Oxford Shirts Ltd.

Pretty Square, South Salna, Salna, Gazipur
(24.035049N,90.388135E)
2nd March 2017

Observations

Column Layout

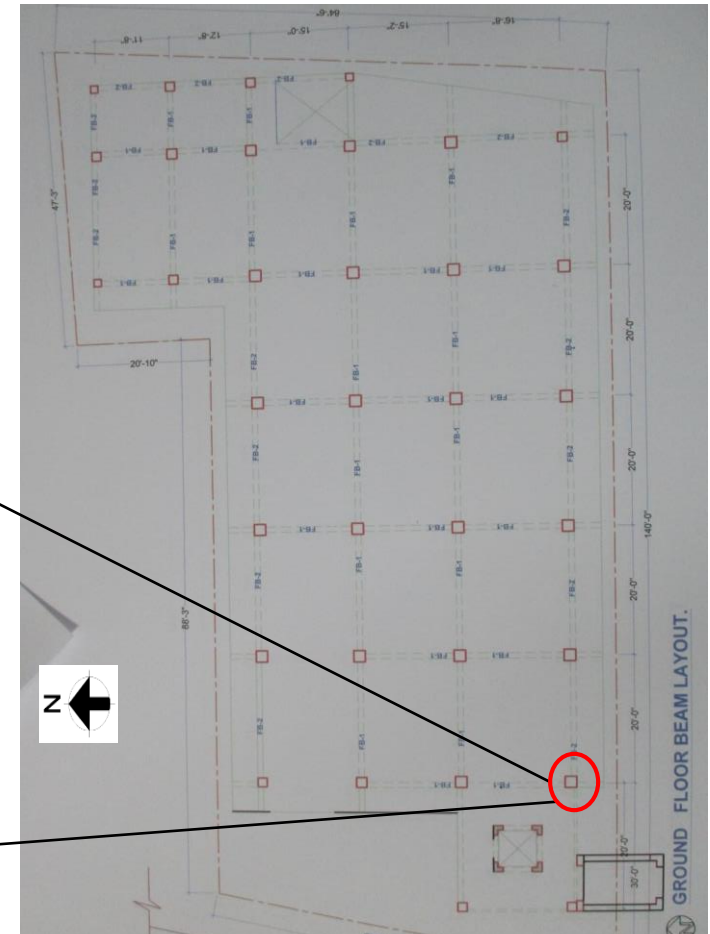
Insufficient As-built drawings

Additional RC column with 12 number of rebar

Exposed rebar of the Additional column

Additional 300 x 525 mm RC column with 12 number of rebar was observed adjacent to the column C1 near west side stair zone of the main (part-1) building

8th Floor Plan

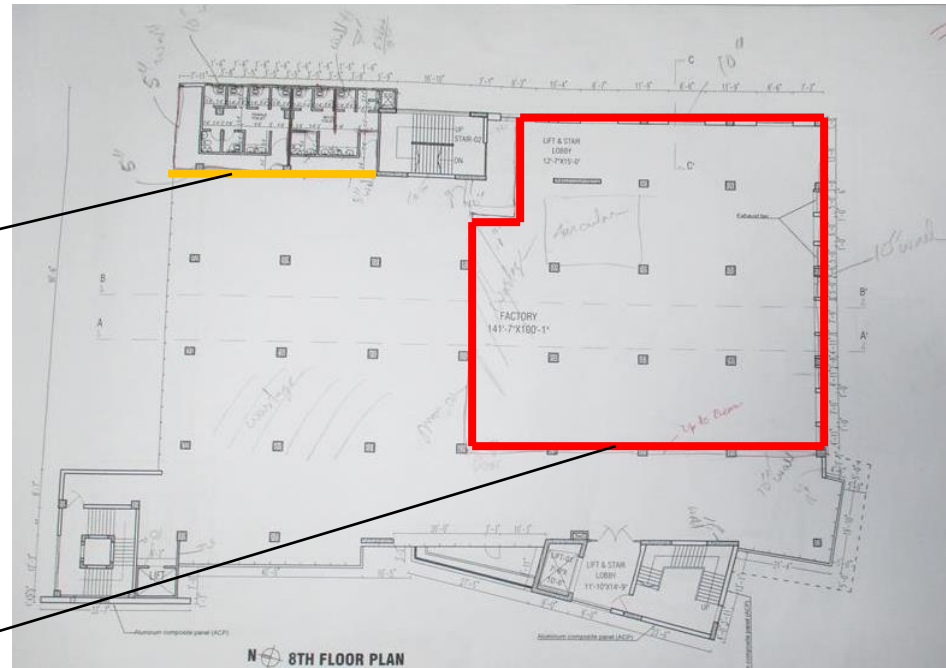
Internal 5" brick walls not shown in as-built drawings

Internal 10" full height brick walls not shown in as-built drawings.

As-built architectural drawings for the internal partition wall does not match with as-built conditions. Building engineer to survey the structure and update the as-built (architectural & structural) drawings for all buildings based on actual scenario.
